Title & Document Type: HP 339A Operating and Service Manual

Manual Part Number: 00339-90001

MODEL 339A

DISTORTION MEASUREMENT SET

Figure 4-13. Input Impedance Test.

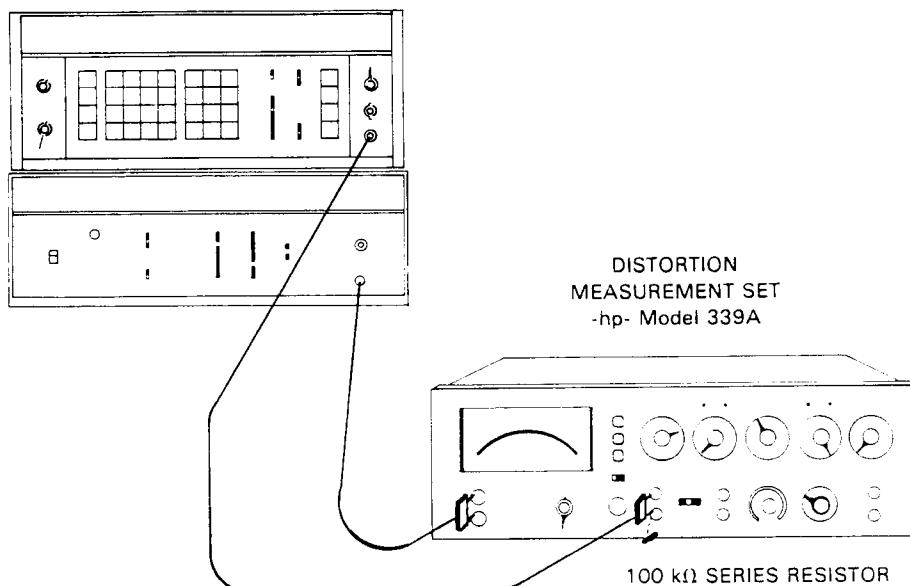
Page 4-12, Paragraph 4-26b. The sentence should read, "Connect the equipment as shown in Figure 4-13 without the 100 k Ω series resistor."

Figure 5-3. Adjustment Locations.
5-7/5-8

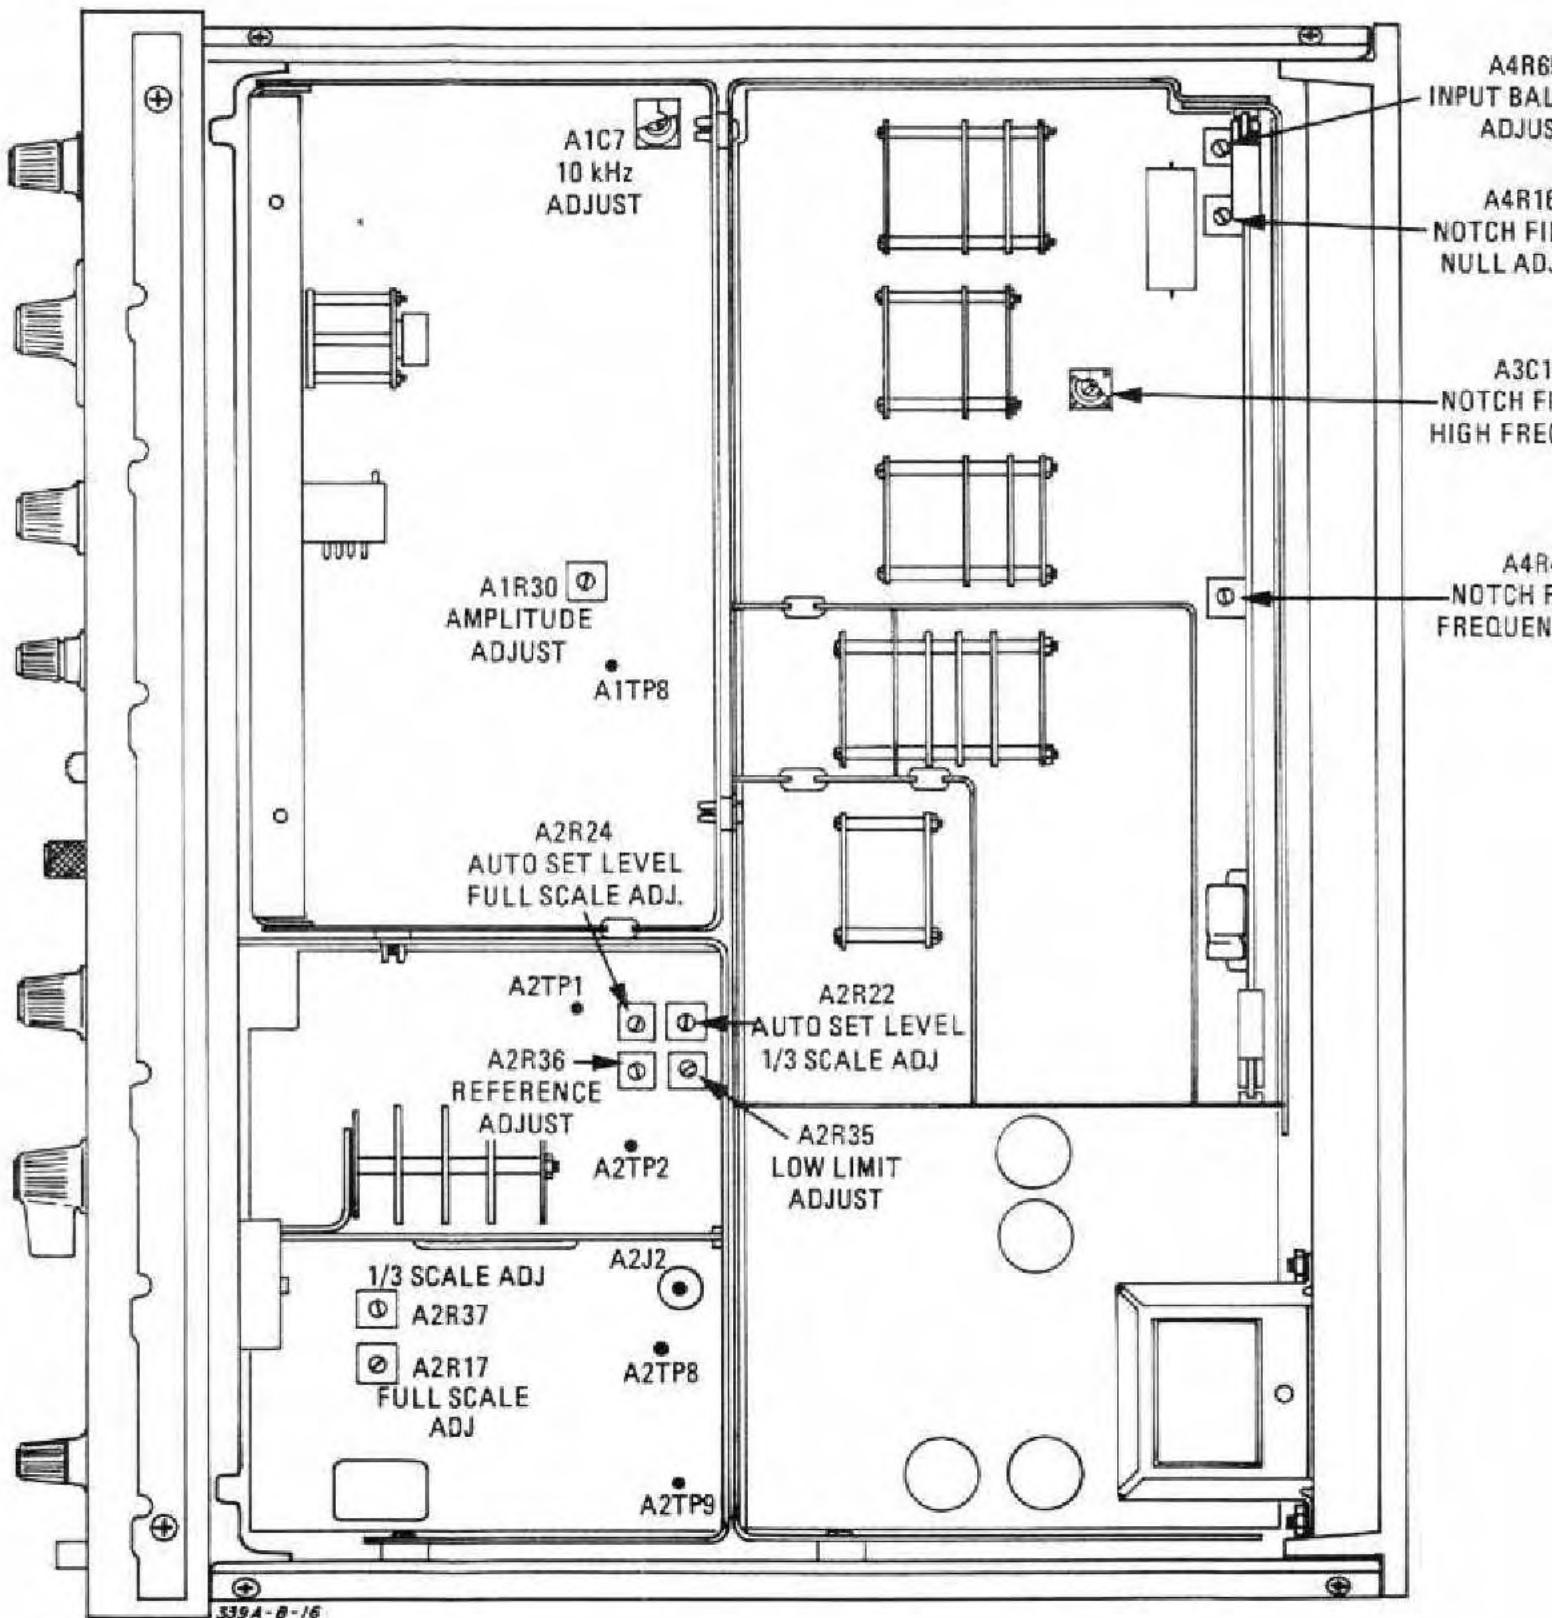
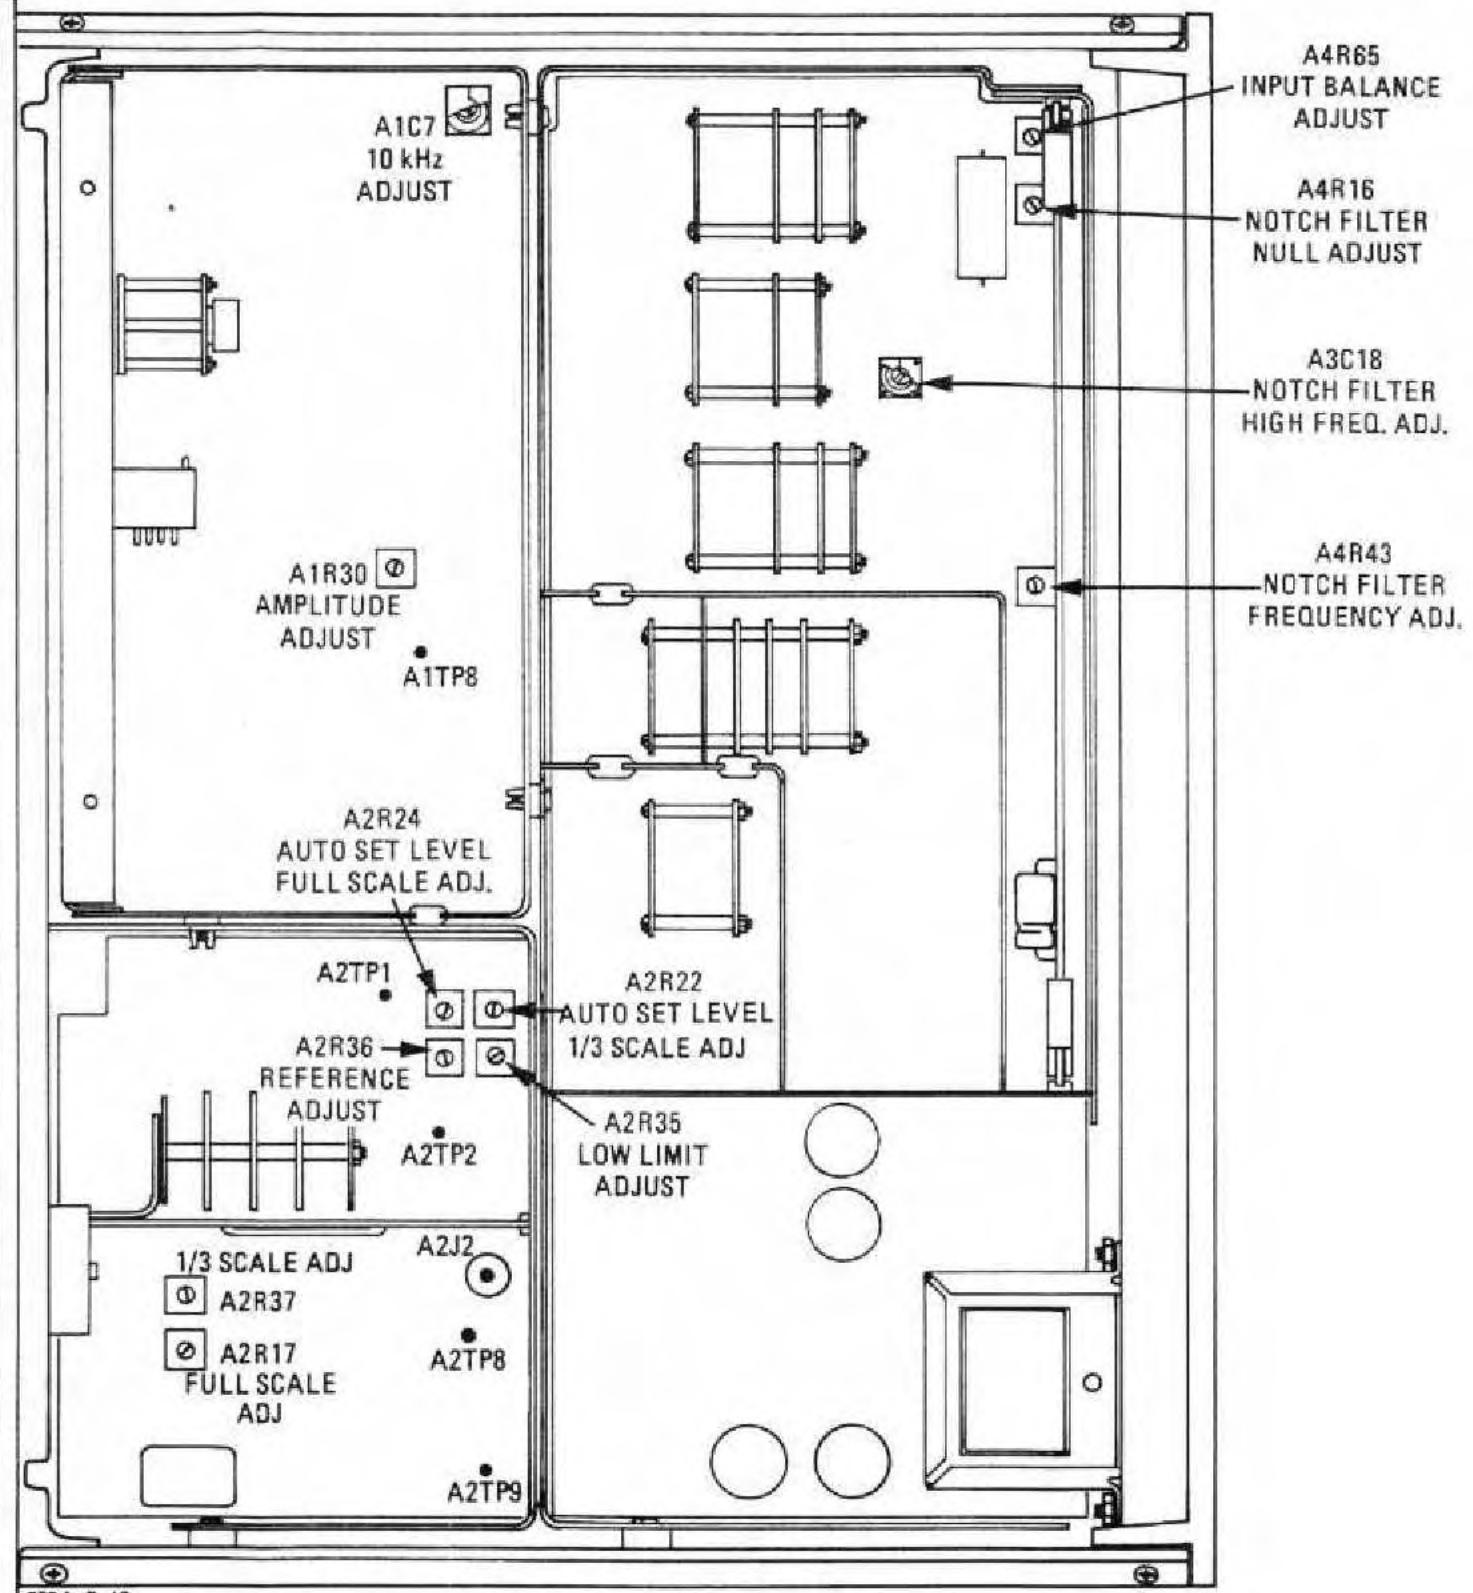
Page 5-7/5-8, Figure 5-3. Switch the part designators and adjustment descriptions on A2R37 and A2R17 shown in the lower left corner of the drawing.

Figure 7-1. Amplitude Control Circuit Change.

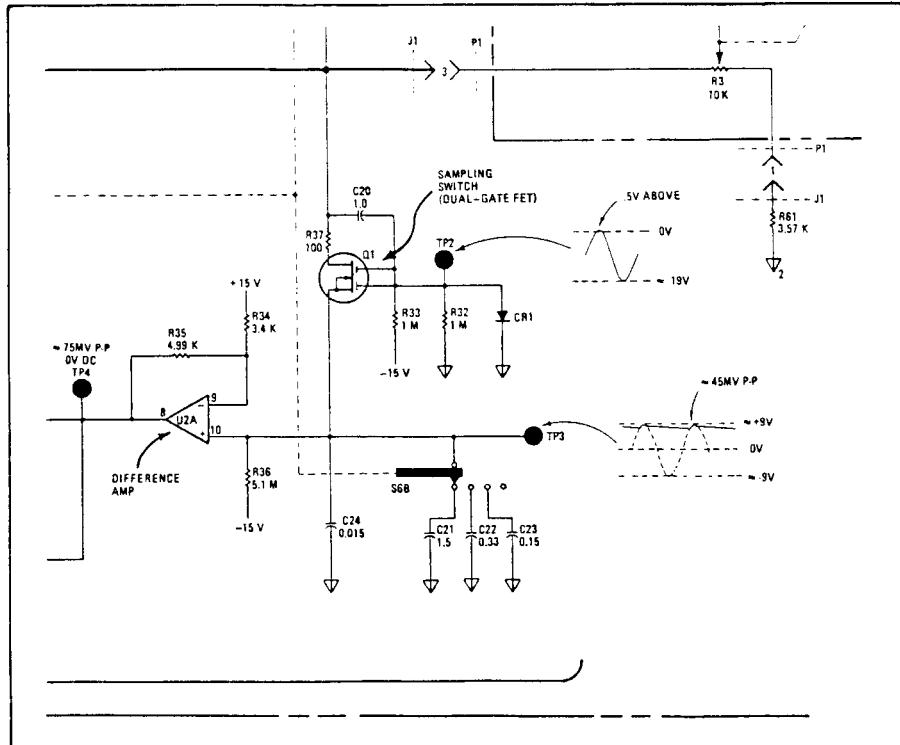
Page 8-21/8-22, Figure 8-17.

Modify the amplitude control circuitry as shown in Figure 7-1.

Figure 8-12. AM Detector and Input Switching.
8-11/8-12

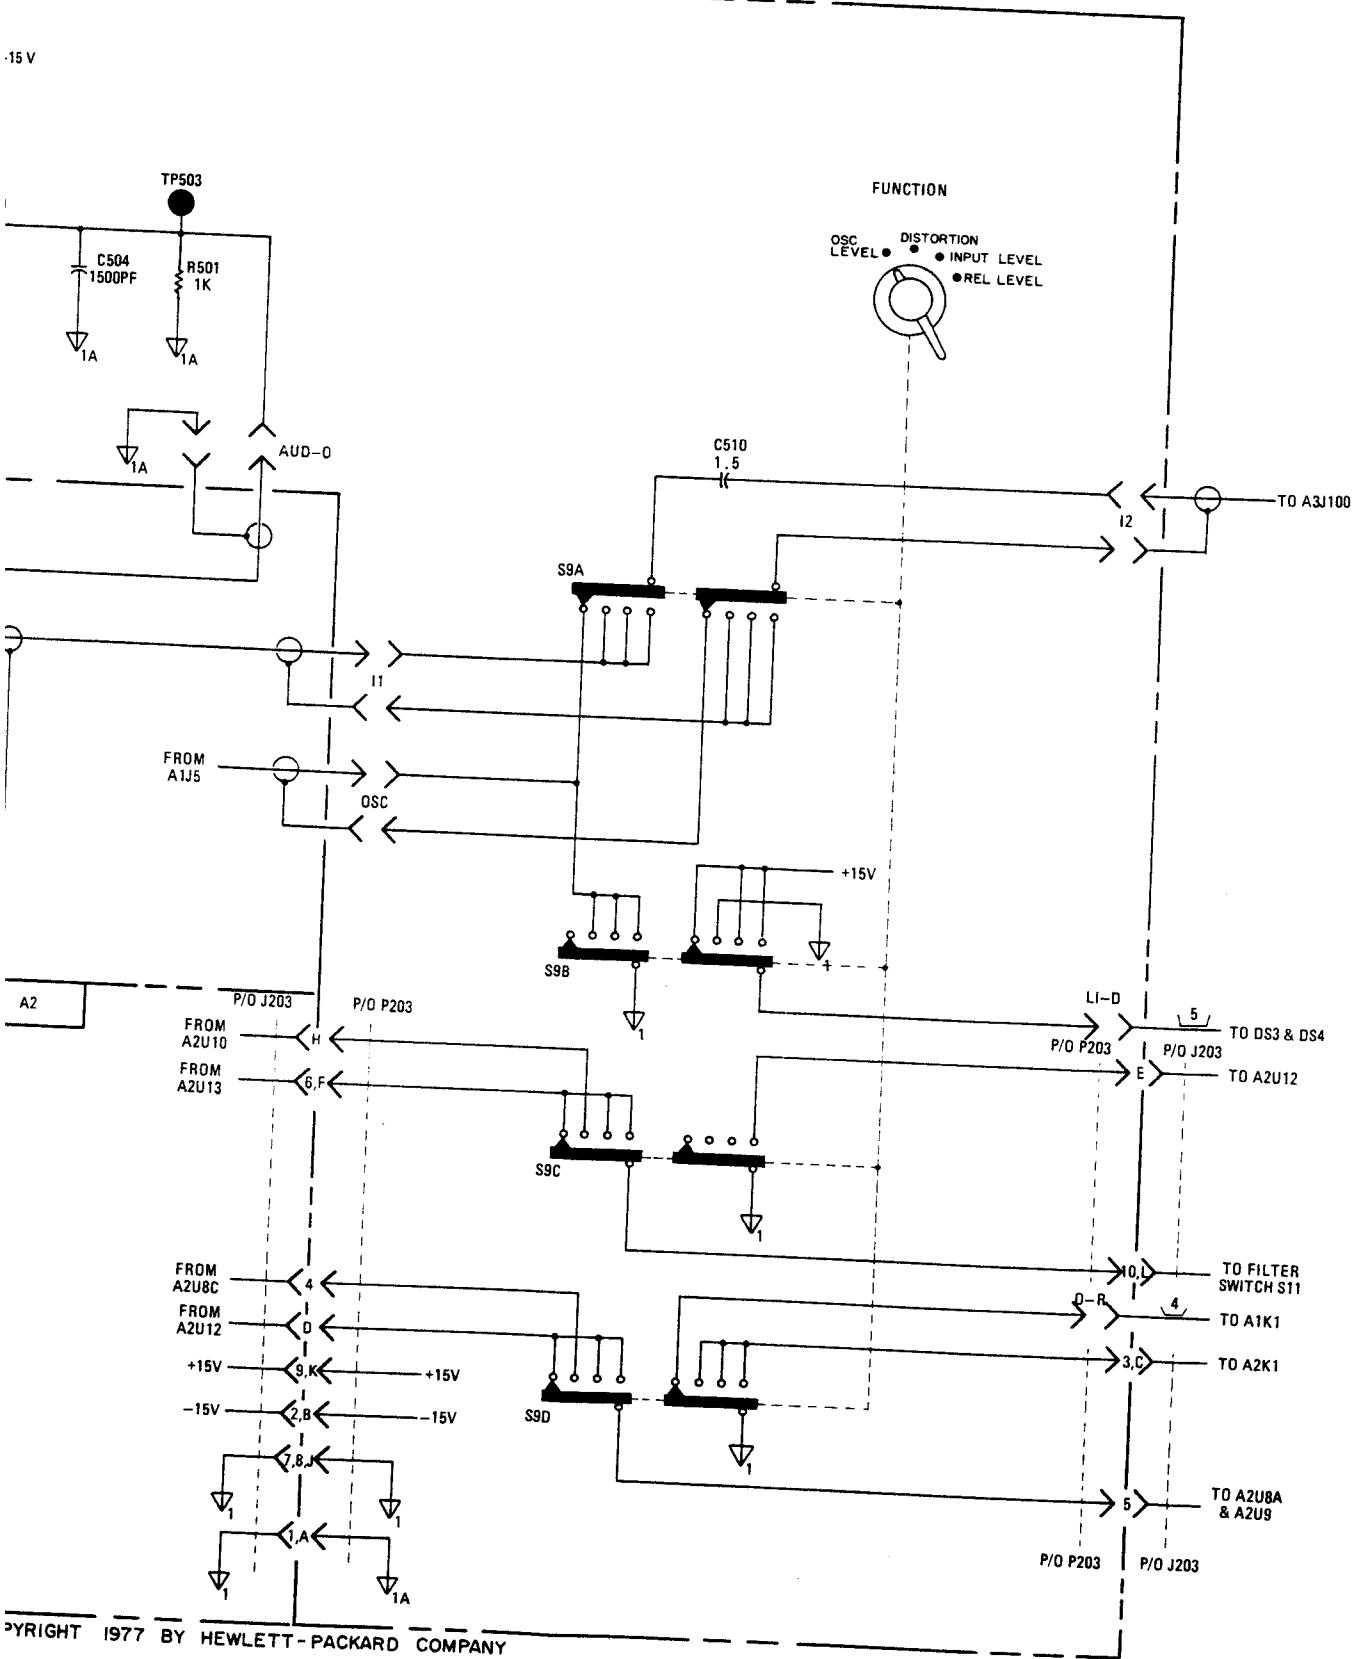
8-11/8-12, Figure 8-12. Change the value of capacitor C1 from .01 to .01 mfd.
